UNITED STATES PATENT AND TRADEMARK OFFICE

APPLICATION NO.	FILING DATE	FIRST NAMED INVENTOR	ATTORNEY DOCKET NO.	CONFIRMATION NO.
10/767,637	01/29/2004	Michael D. Mason	2731/103	5420
2101	7590	03/24/2005	EXAMINER	
BROMBERG & SUNSTEIN LLP 125 SUMMER STREET BOSTON, MA 02110-1618			REIMERS, ANNETTE R	
			ART UNIT	PAPER NUMBER
			3732	
DATE MAILED: 03/24/2005

Office Action Summary	Application No. 10/767,637	Applicant(s) MASON, MICHAEL D. ed	
	Examiner Annette R. Reimers	Art Unit 3732

DETAILED ACTION

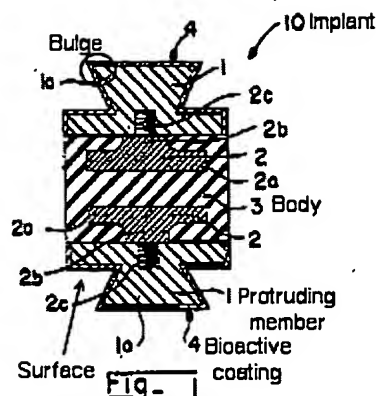
Claims 1-5, as understood, are rejected under 35 U.S.C. 102(b) as being anticipated by Hirayama et al. (U.S. Patent Number 4,946,378).

Hirayama et al. disclose a method for fusing a first vertebra to a second adjacent vertebra (see figure 3). The method comprises providing an implant, e.g. 10 of figure 1 below, comprising a body, e.g. 3 of figure 1 below, having first and second opposite surfaces (see figure 1 below), wherein each of the surfaces includes at least one protruding member, e.g. 1 of figure 1 below, for securing the body to an adjacent vertebra and wherein the implant has sufficient tensile and sheer strength to permit fusion of the vertebrae (see column 2 lines 18-20) and each of the surfaces and protruding members includes a bioactive coating, e.g. 4 of figure 1 below.

The method further comprises forming at least one keyway in the first vertebra corresponding to each of the at least one protruding members on the first surface and at least one keyway in the second vertebra corresponding to each of the at least one protruding members on the second surface (see figure 3 and column 3 lines 34-40). In addition, the implant is inserted between the first vertebrae and the second vertebrae in a manner so that each protruding member slides into the corresponding keyway (see column 2 lines 6-8), such that fusion of the vertebrae is achieved without a bone graft. (see column 1 lines 44-50).
